**Design Addendum**

For Reselton Properties

This Design Addendum has been prepared in direct response to a series of comments provided by London Borough of Richmond Upon Thames regarding the submitted proposals for the former Stag Brewery site in Mortlake.

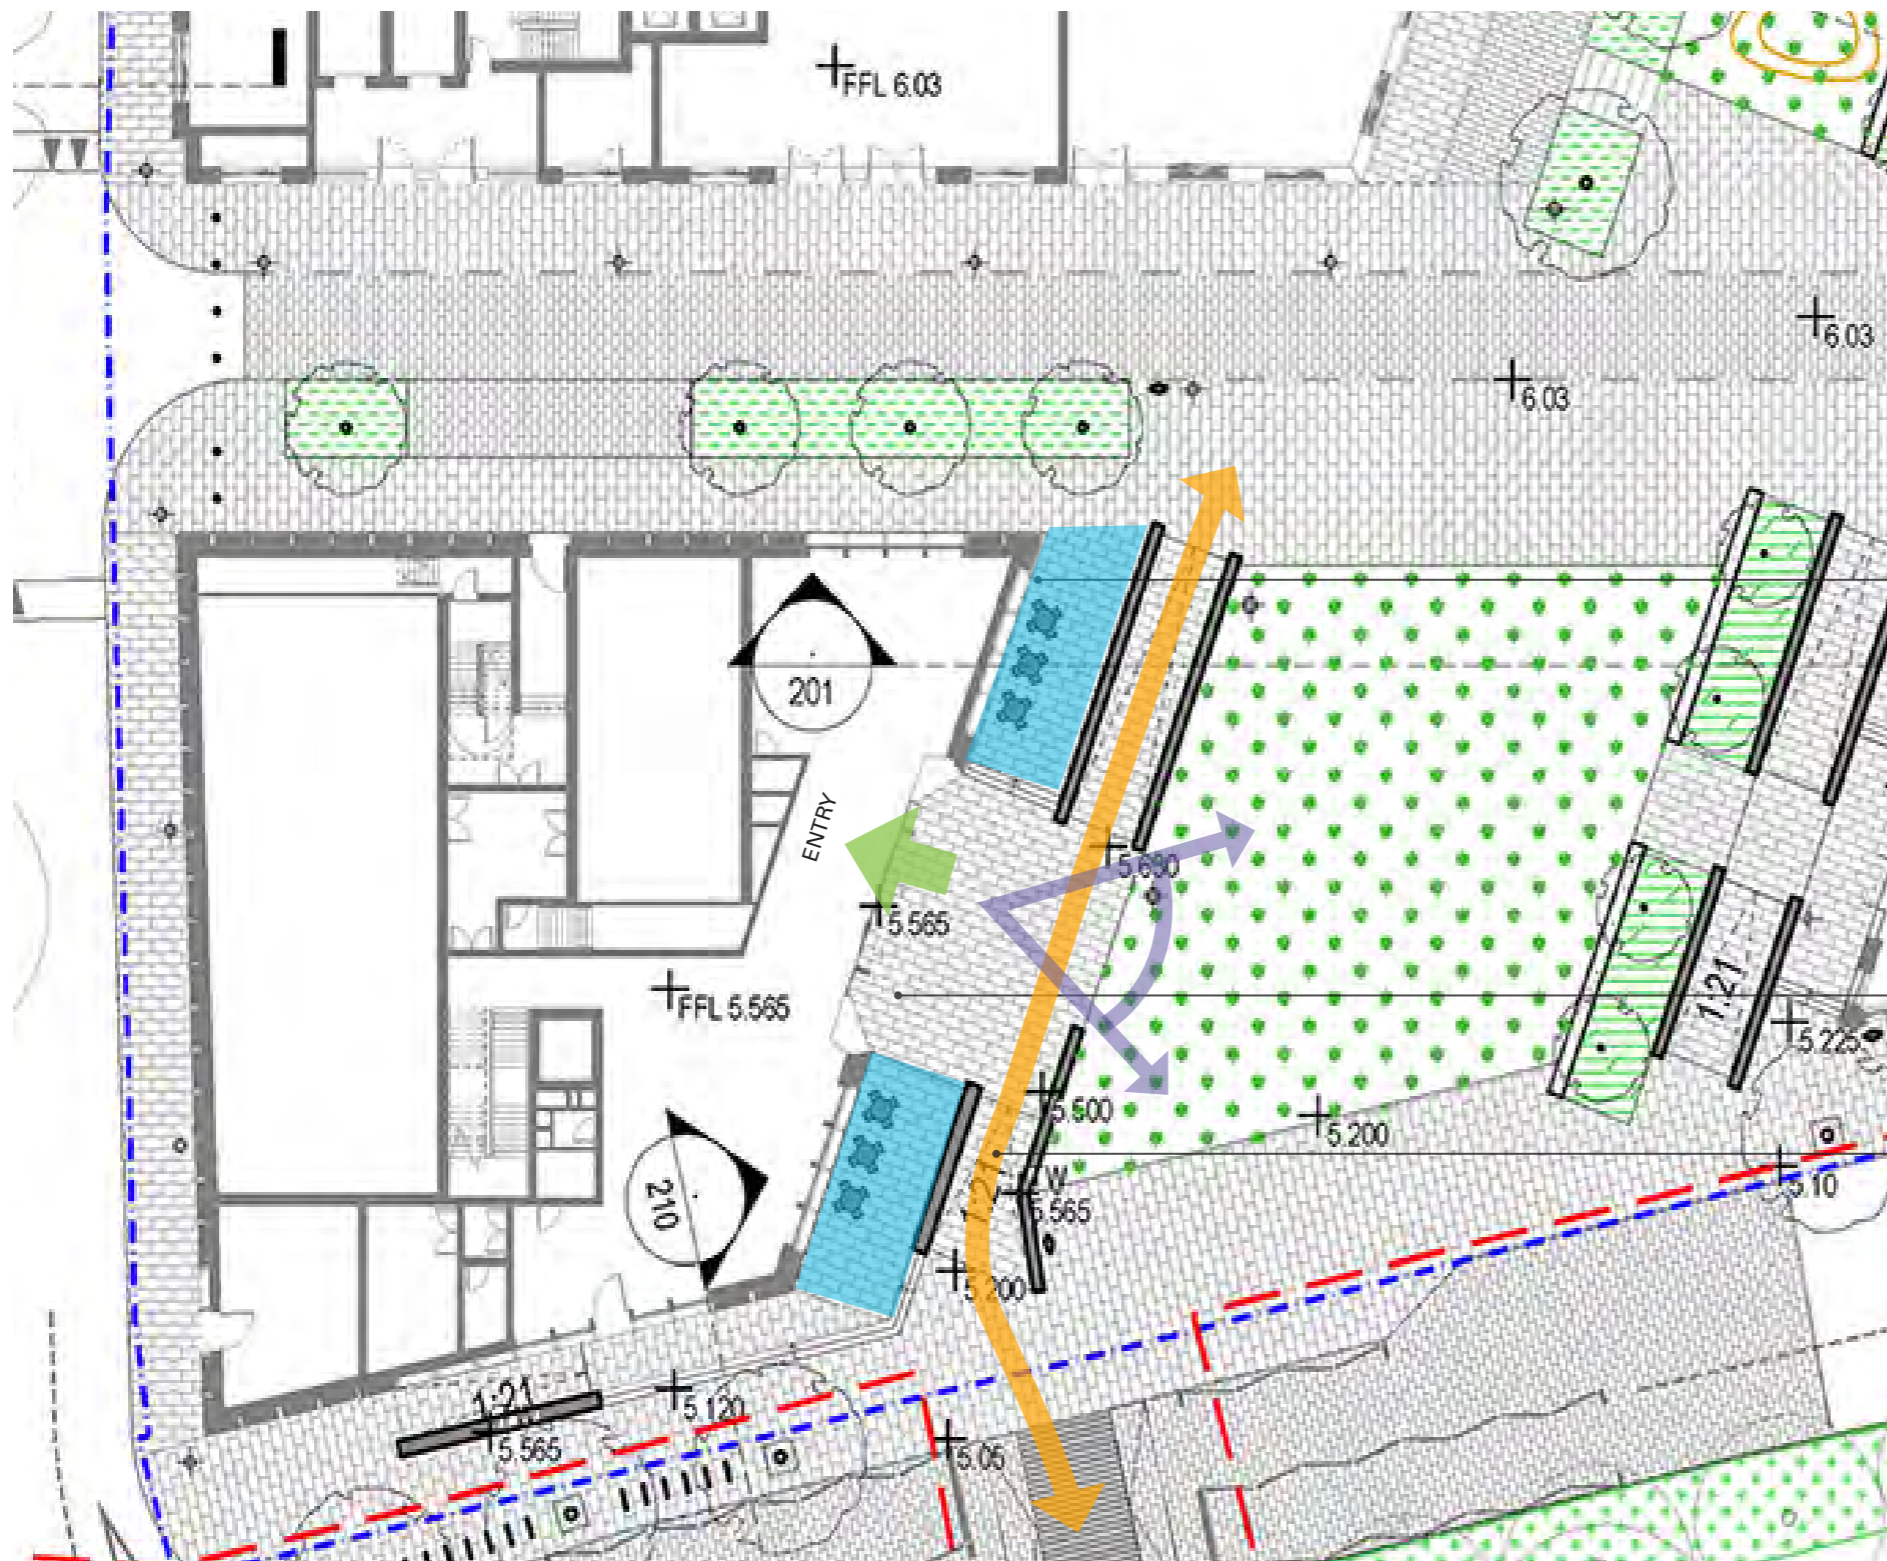
2. Provide direct level access to omit steps and ramps.

The proposed floor level of the Cinema is set mid-way between proposed Thames Street and Lower Richmond Road (LRR) and provides the ground floor of the building with relationships to both streets and to the public open space and, particularly to the circulation route and gathering space of the Green Spine.

Gillespies have designed the access around the building to provide steps and accessible walkways into a central entrance landing facing into the Green Spine. The main access route from LRR and Mortlake Green and beyond is via the graded walkway that runs either side of the Green Link directly through the site to the river. Graded slopes of 1:21 incline and edged with raised kerbs / seating walls provide an accessible route to the main eastern entrance and past the building, linking LRR and Thames St. Outside the cinema, there are level areas that form spill-out terraces, slightly raised above pavement level and overlooking the Green Spine and LRR, providing animation to the streetscape as well as valuable amenity space for the users of the cinema.

A secondary direct entry from LRR is provided with a continuous line of steps wrapping the corner and an accessible graded walkway at the western end down to footpath level. The configuration of these steps and graded walkway is designed to maintain a min public footpath along LRR past the site and

Block 1 (cinema) - Proposed north elevation

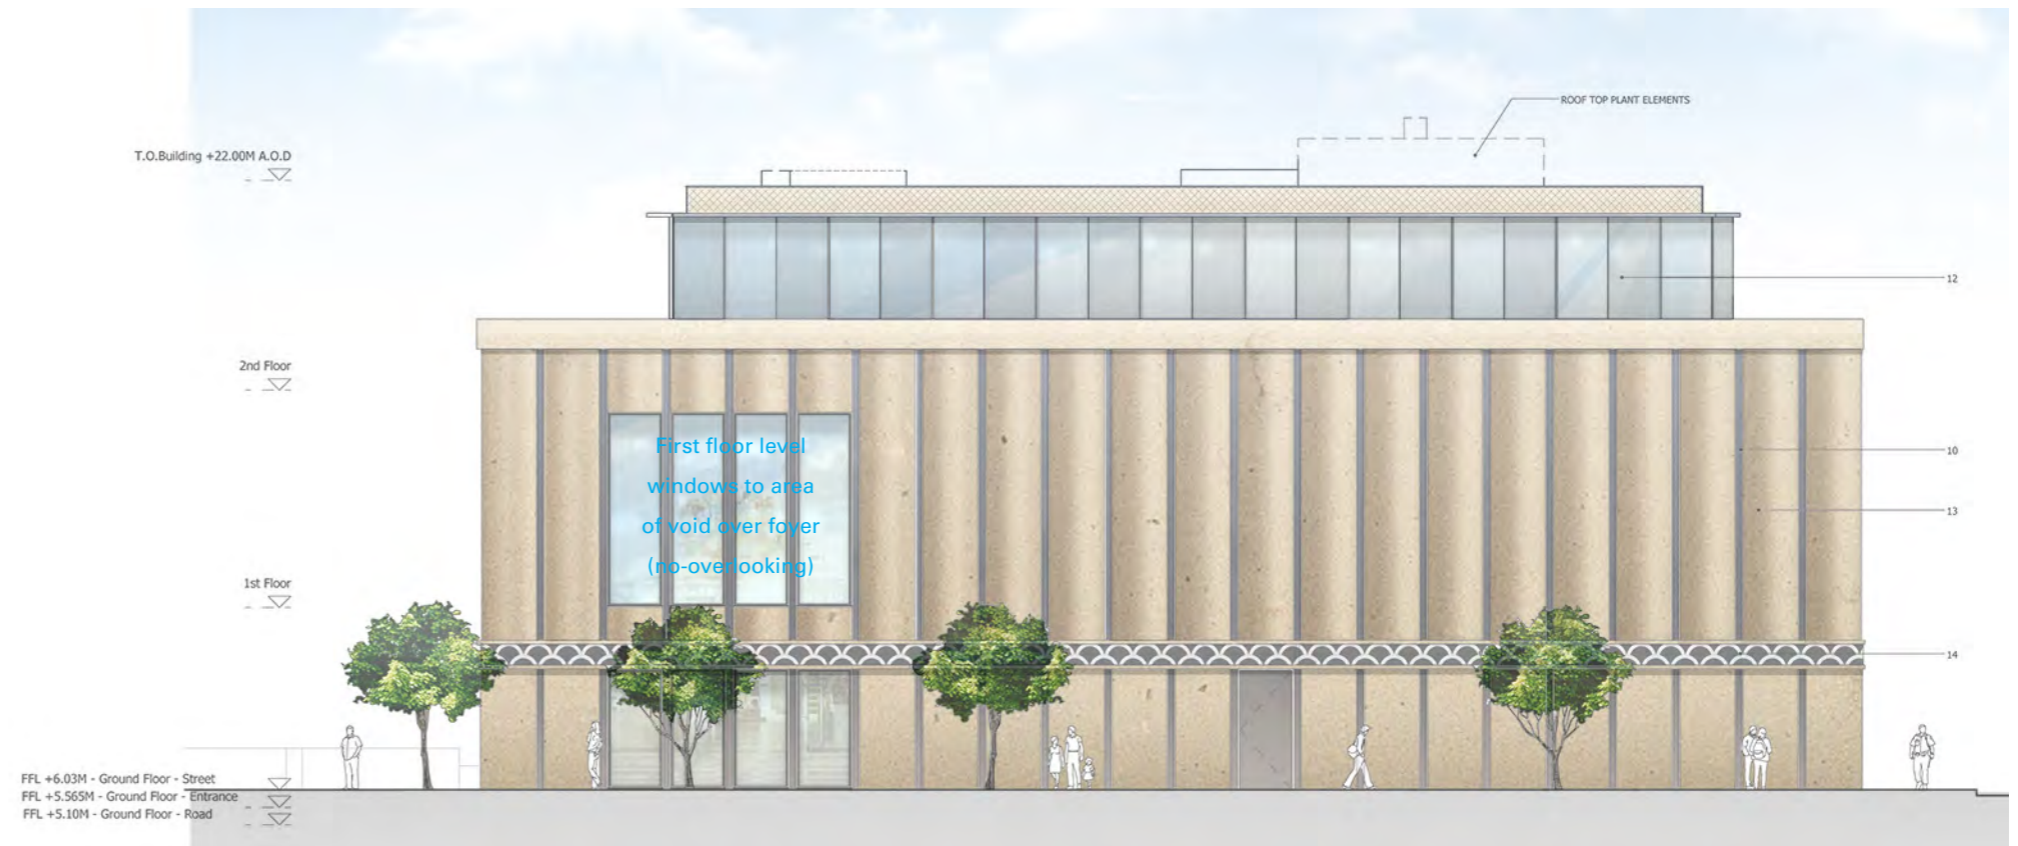
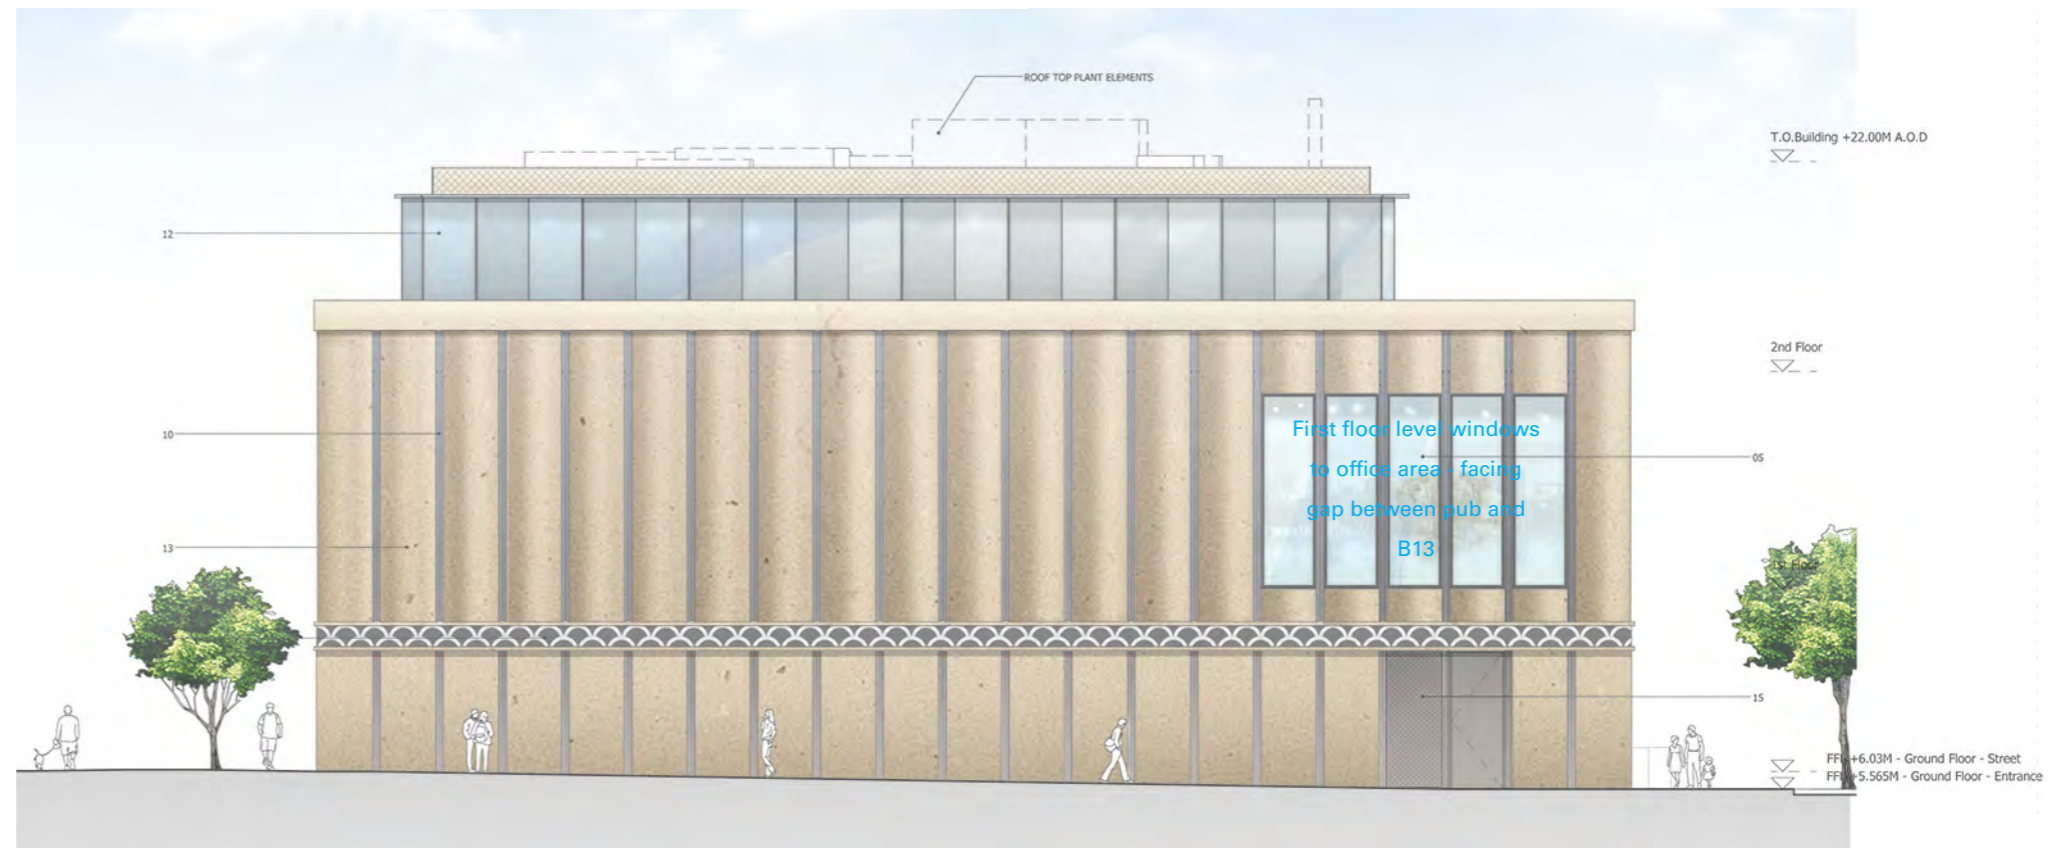
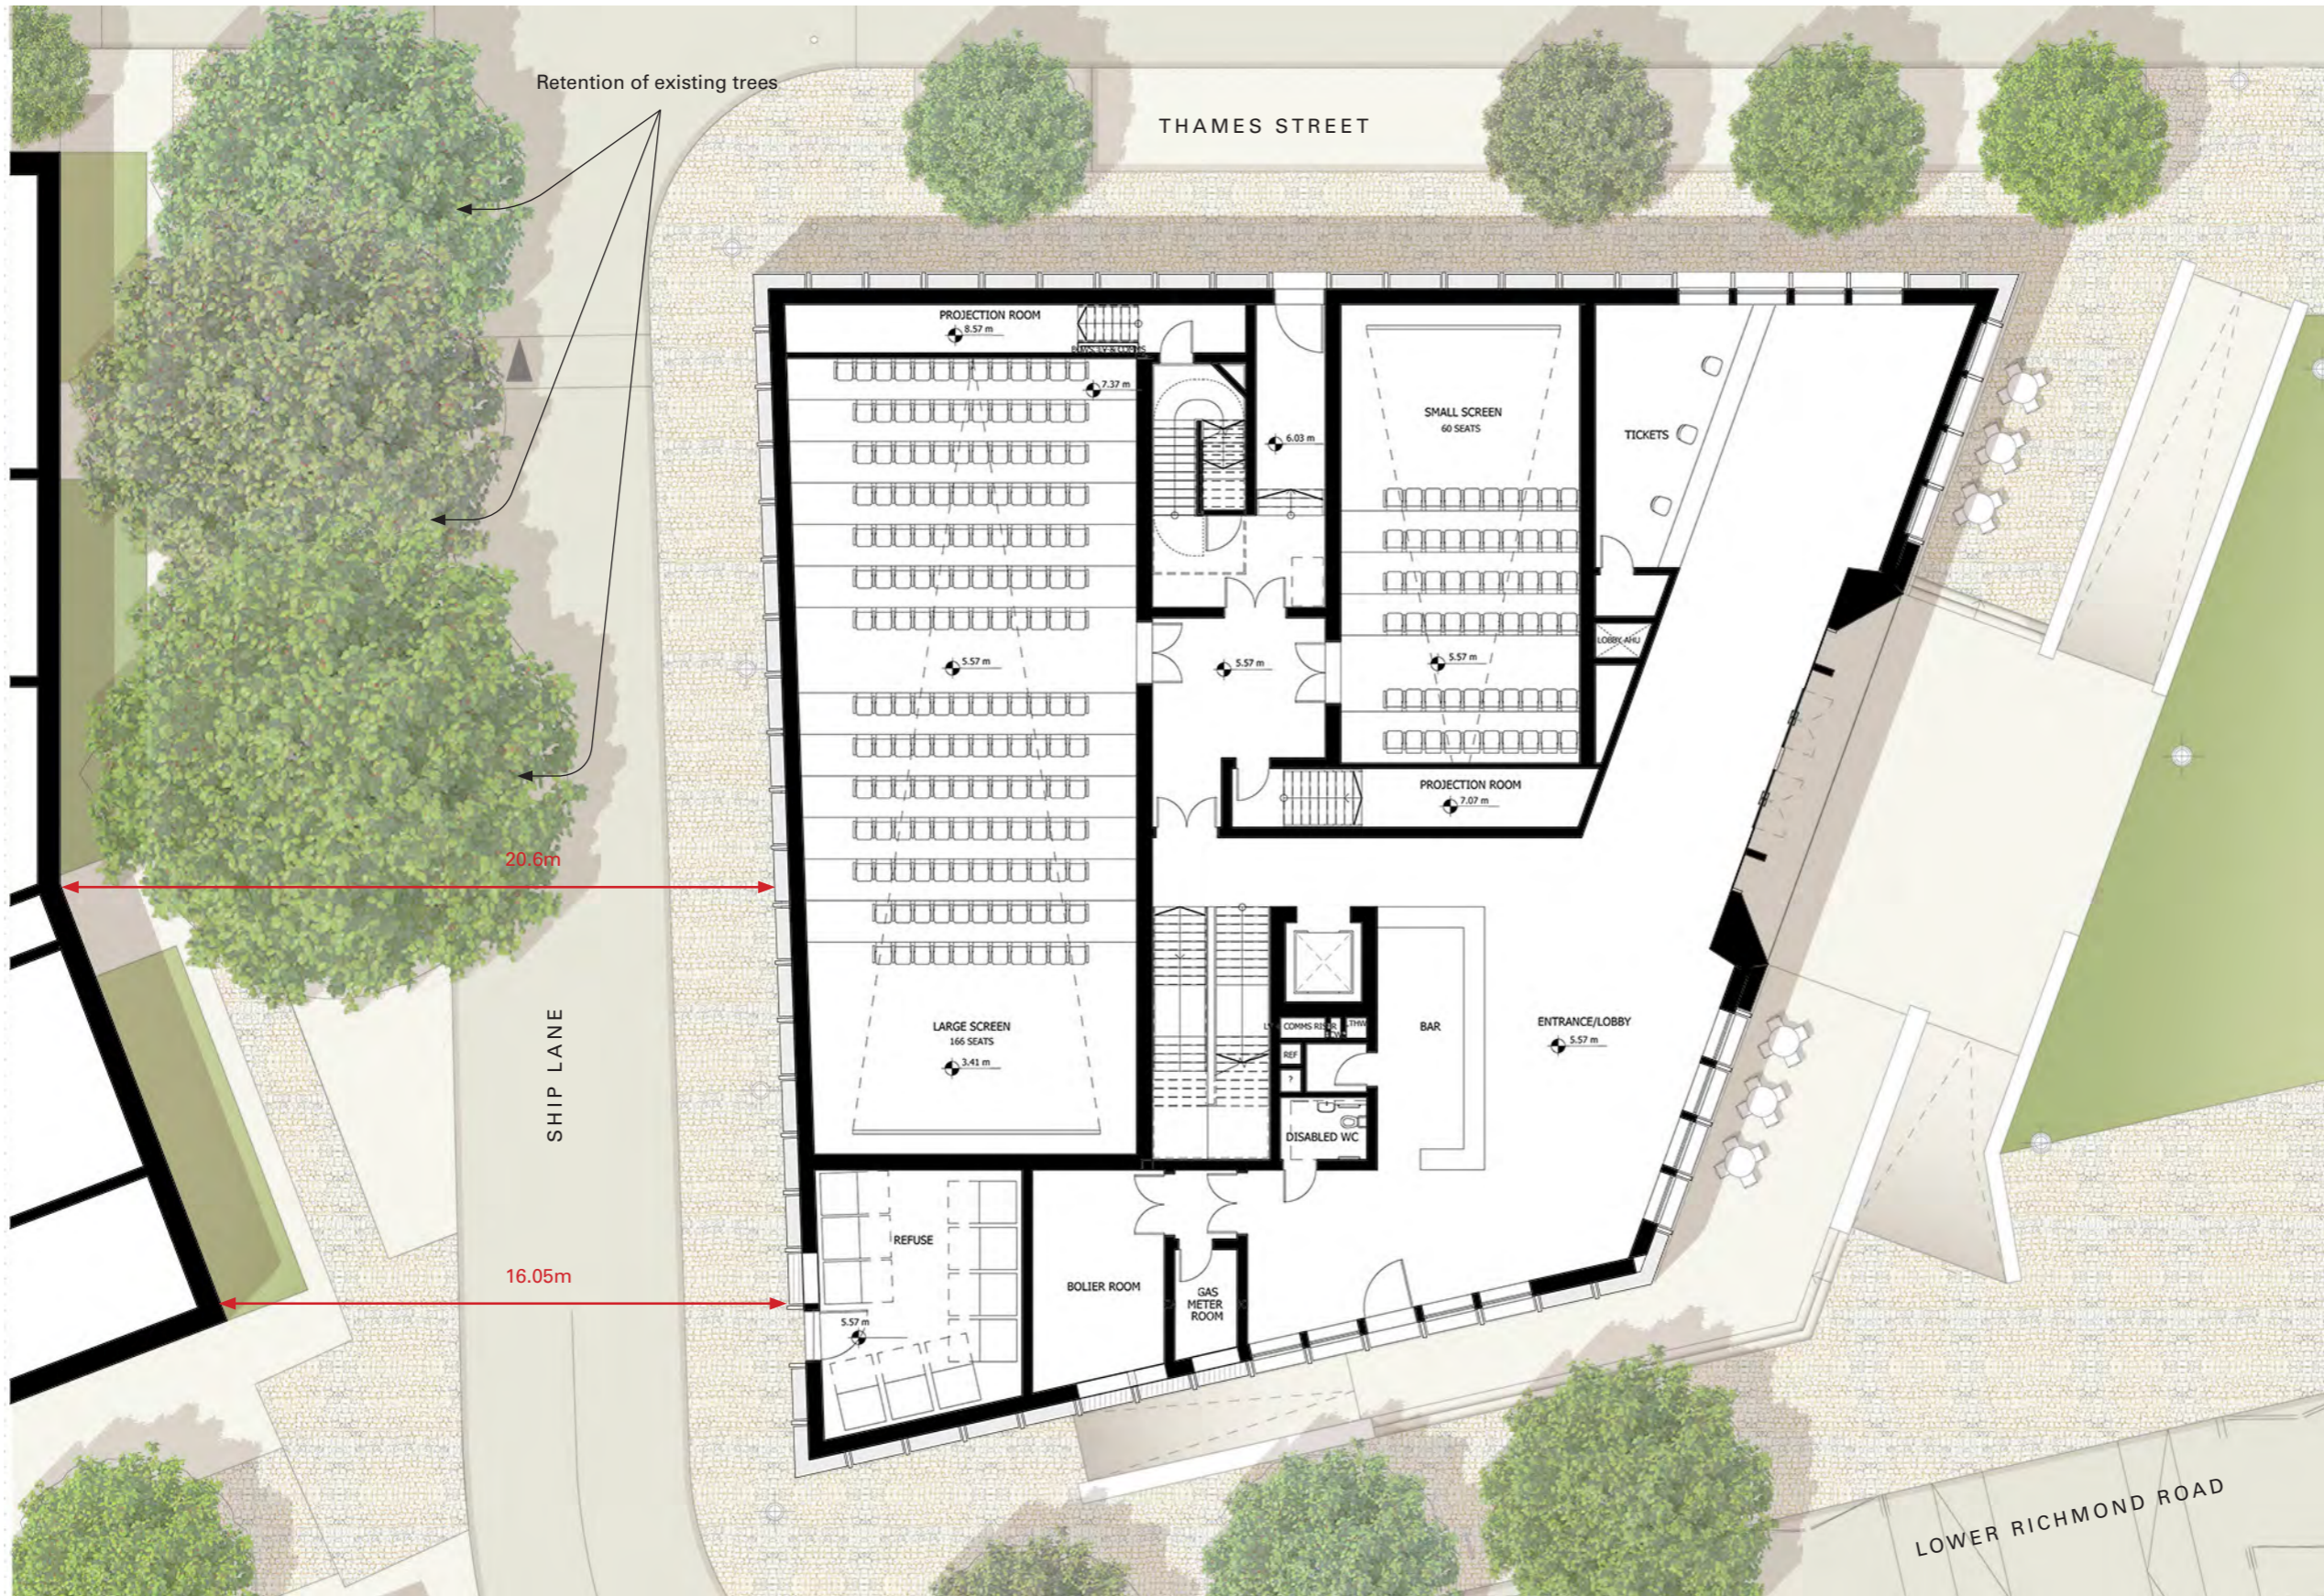
- West and north elevations. The main view for future residents appears to be of 4 storeys of solid pre-cast concrete cladding. This will have adverse effect on the value of the residential units?

The nature of the use of the building as a cinema requires a large proportion of windowless facades. On one hand this means that those parts of the facade are not animated by windows, however that may also be seen as a benefit in terms of the lack of overlooking issues to these areas. The internal configuration of the building has been designed to specifically locate the screens (which require solid facade) to the north and west - this has been to ensure active frontages are provided towards the green link and Lower Richmond Road. The elevation treatment has been carefully considered to provide strong character and relief. The fluted concrete piers will cast light and shadow in a manner reminiscent of a cinema curtain - not dissimilar to the effect of the award winning Centre for Contemporary Arts in Nottingham (by Caruso St John Architects). By evening this fluted profile provides opportunity for subtle lighting to be incorporated in a manner that avoids light spilling towards its neighbours. We believe this is a suitably elegant approach to the challenge of providing solidity and animation at the same time.
